Re: Site Plan Application Review
Map 7, Lot 39 and 39-1
Warner, New Hampshire

On behalf of the Town of Warner (Town) Planning Board, Aries Engineering, LLC (Aries) prepared this engineering review of a Site Plan application for the property identified as Lots 39 and 39-1 on Warner Tax Map 7 (site) in Warner, New Hampshire.

RE: Jennesstown Manor Site Plan Application
Tax Map 7, Lots 39 & 39-1 – Warner

Our office is in receipt of the Aries Engineering review comments dated Oct. 20, 2025, and the Fire Department comments dated July 6, 2025. Based on the comments, we have made the required modifications and attached revised plans for review. A response to each comment has been provided below.

REVISIONS			
No.	DATE	DESCRIPTION	BY
1	5/22/25	PER PB AND AOT COMMENTS	AEW
2	9/4/25	PER AOT COMMENTS	AEW
3	10/2/25	PER AOT COMMENTS	AEW
4	10/31/25	PER ARIES & FIRE COMMENTS	JDL
DATE: MARCH 25, 2025		SCALE: 1" = 40'	
PROJECT NO: 24-0307-1		SHEET 6 OF 16

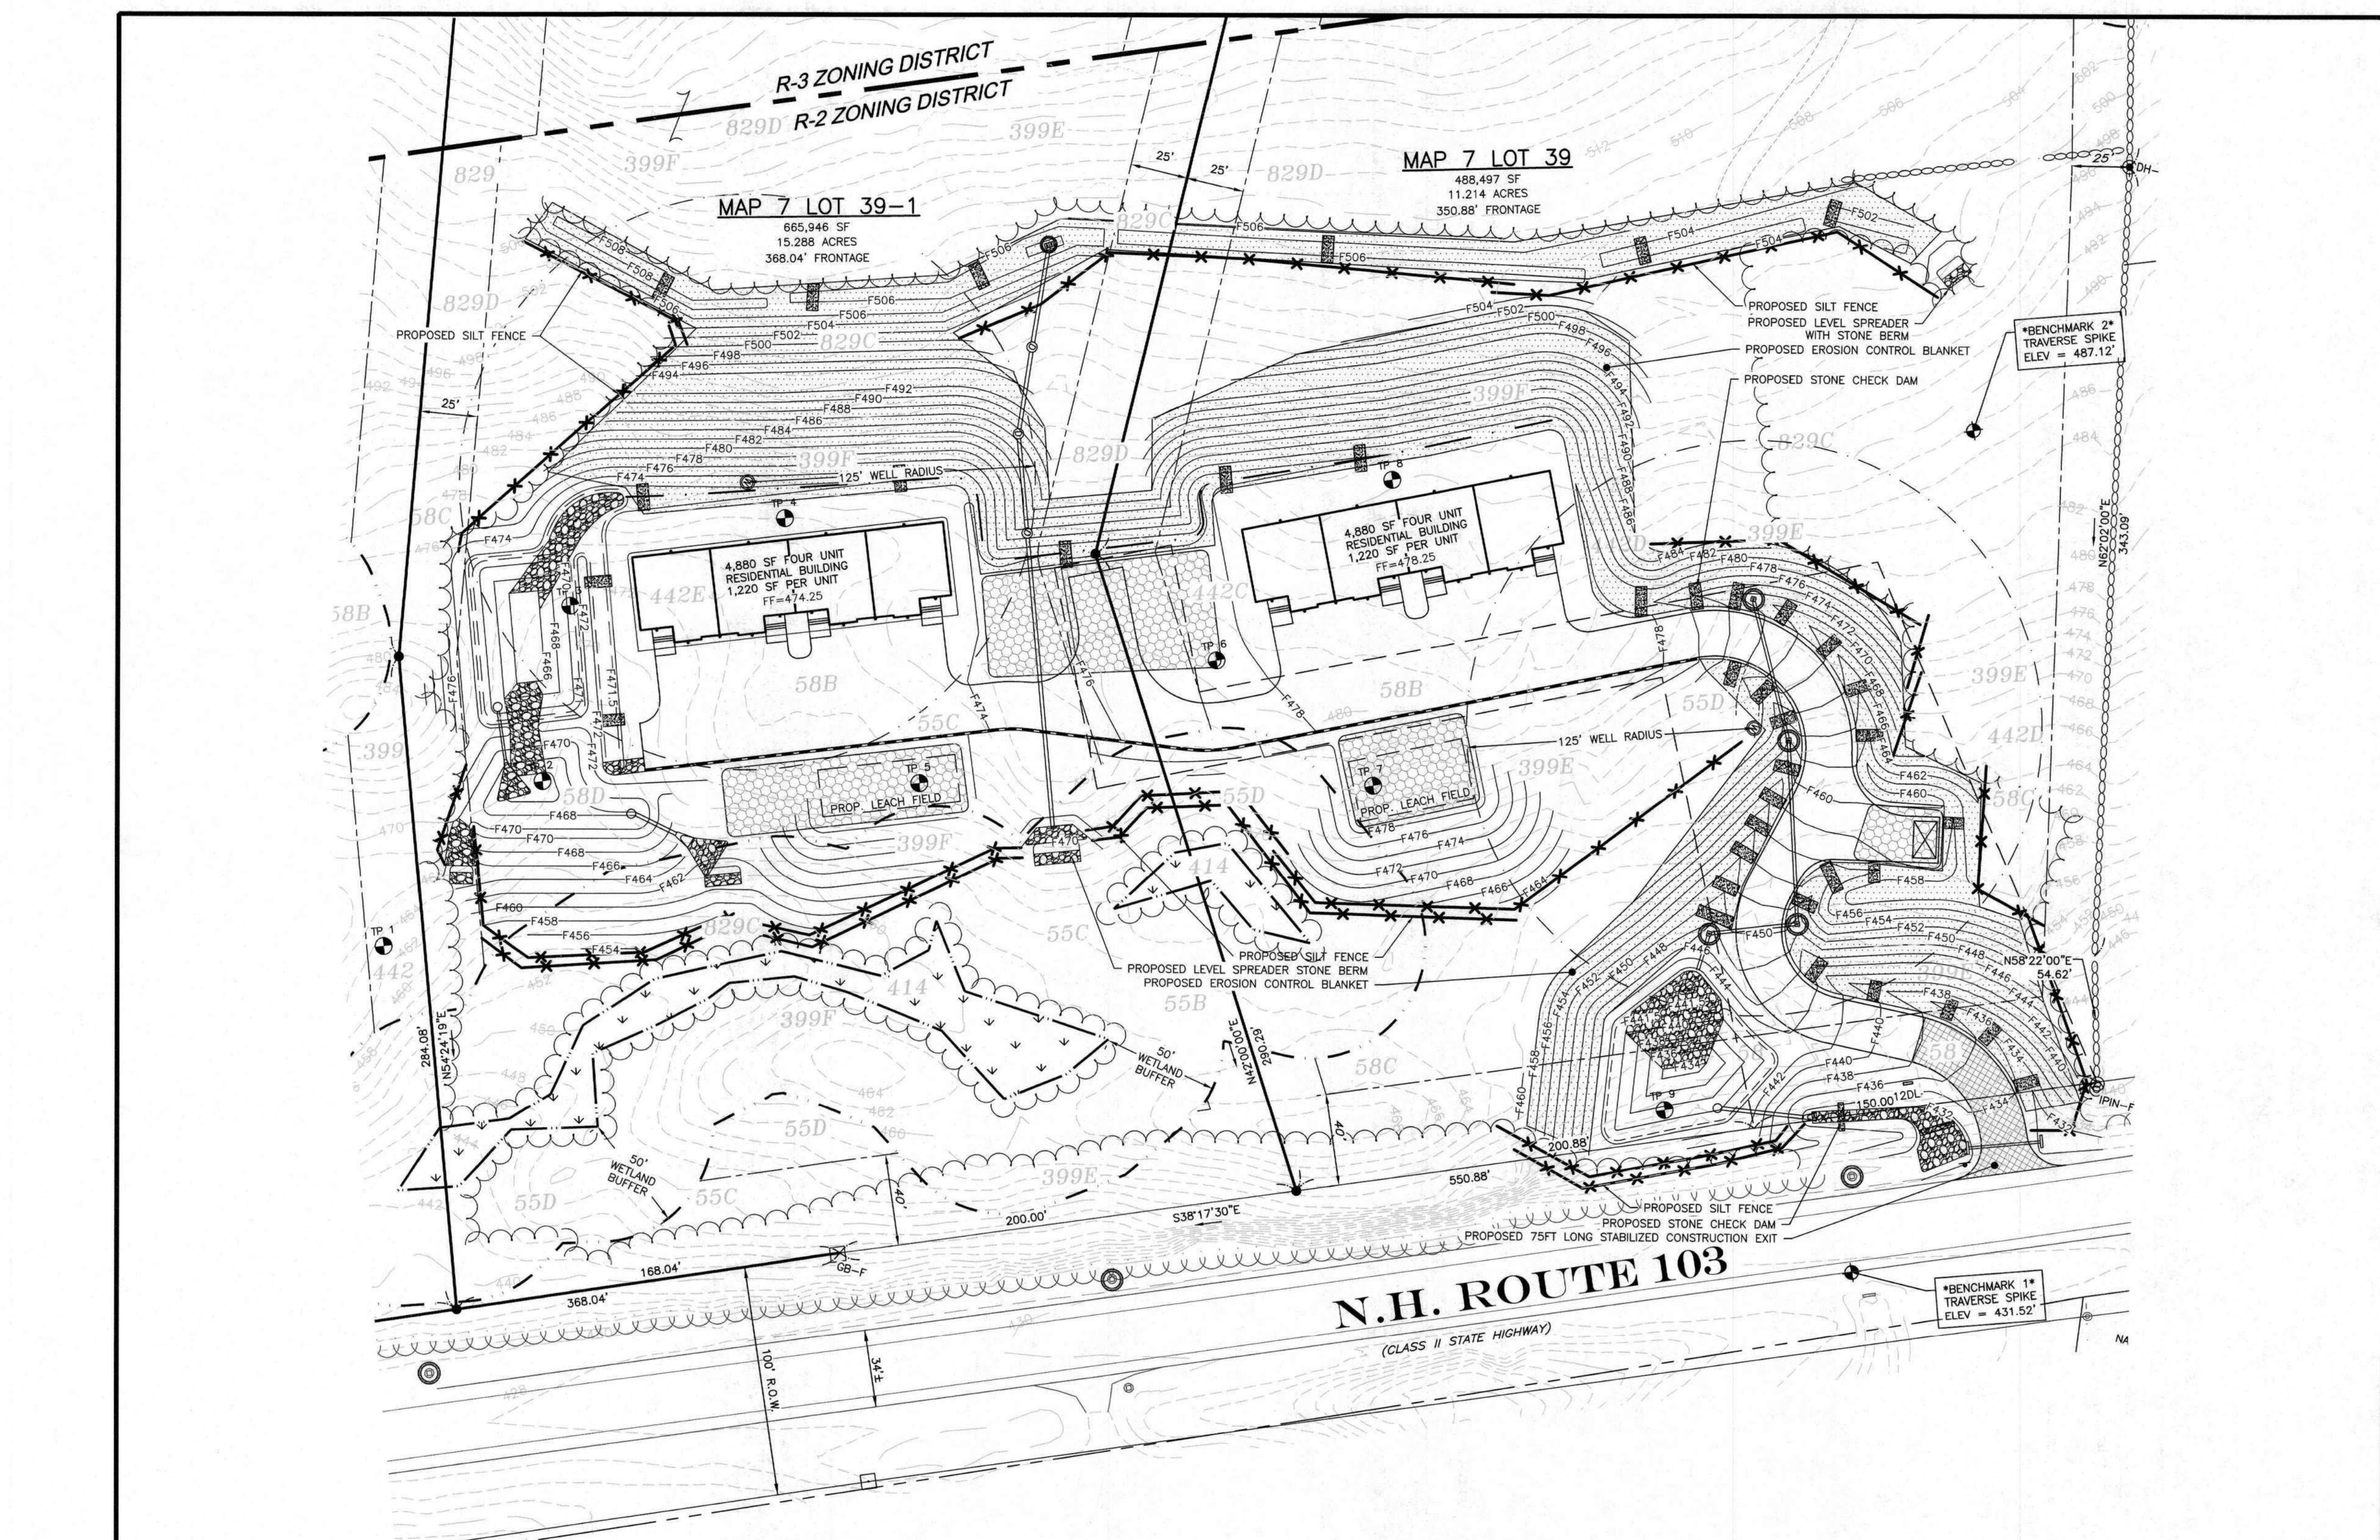
27. Erosion Control notes are provided in the site plan construction details. Aries recommends that the Town conduct periodic inspections to ensure that specified erosion control procedures are followed.

Note 10 on Sheet 6 provides the Town oversight on the placement and function of the erosion control.

SHEET 7 OF 16

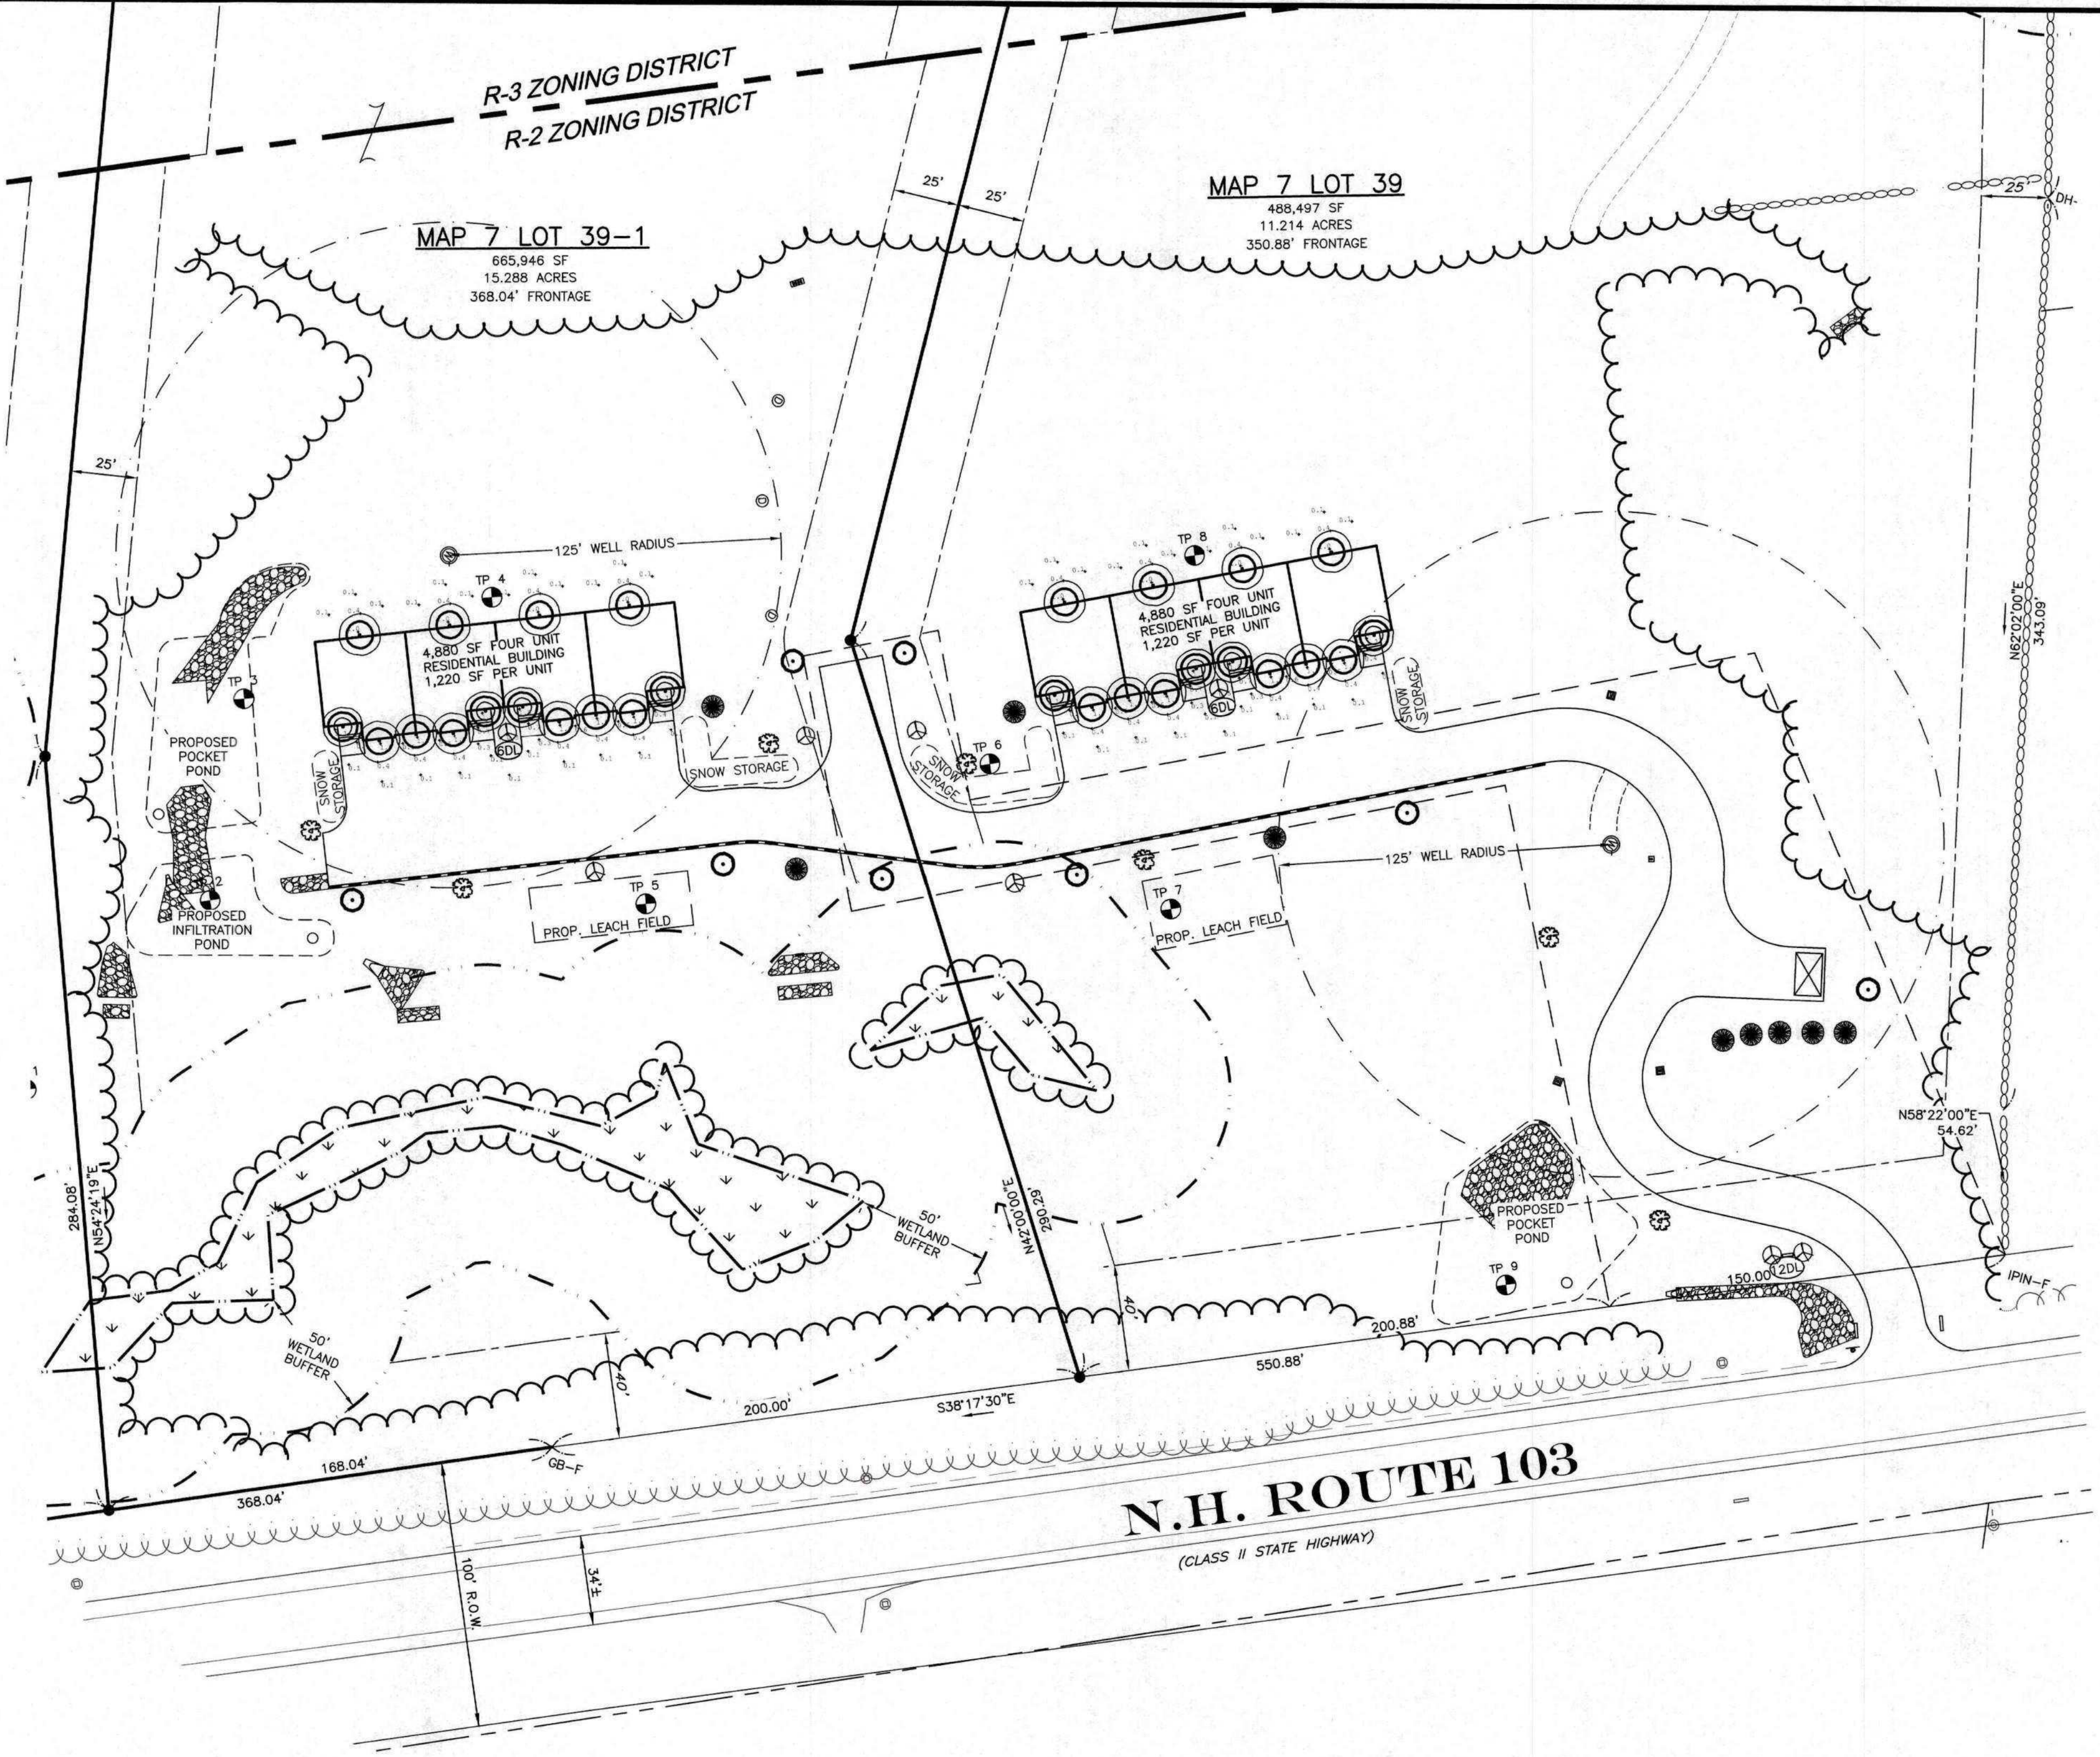
20. Section XVII - Landscaping Standards require a minimum of one 2-1/2" caliper deciduous tree for every 20 parking spaces and every 60 feet of access roads. Available Landscape Plan details list only three deciduous trees to be planted, which does not meet the Town's Landscaping Standards.

The landscape calculations for the deciduous trees have been added to Sheet 7. Twelve additional trees have been added to the plan.
